Thank you for purchasing the PG-FP5 flash memory programmer.

This document describes specifications that have been added or changed, restrictions, and cautions on using the PG-FP5. Also see the user's manual of the PG-FP5 for terminology and points for caution on using the PG-FP5.

Chapter 2 Additions and Changes to Specifications

2.2 Details of additions and changes to specifications

No. 1 Modification of **Cancel** button specification

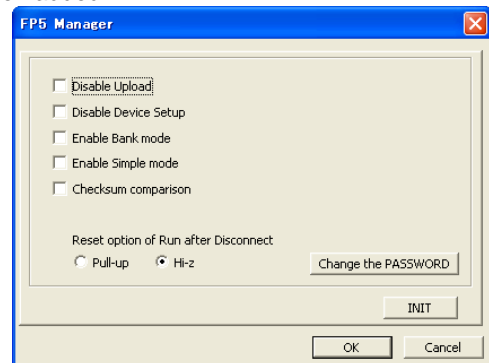
Description: The function of the **Cancel** button on the PG-FP5 main unit has been modified so that cancellation, which was applied to all commands, is only applied to the **Read** command.

No. 15 Addition of **Wide Voltage mode** function

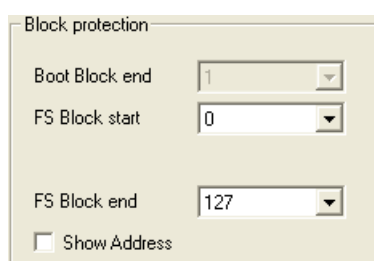
Description: The **Wide Voltage mode** check box has been added to the **Command options** area. If this check box is selected, commands are executed in the wide voltage mode. If this check box is not selected, commands are executed in the full-speed mode. This check box is available when a device supporting this function is selected. For details about the wide voltage mode and full-speed mode, see the user's manual of each device.

No. 16 Change of layout in **Block protection** area

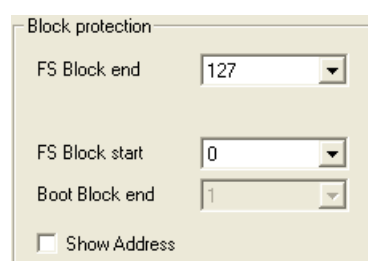
Description: The layout in the **Block protection** area has been changed.
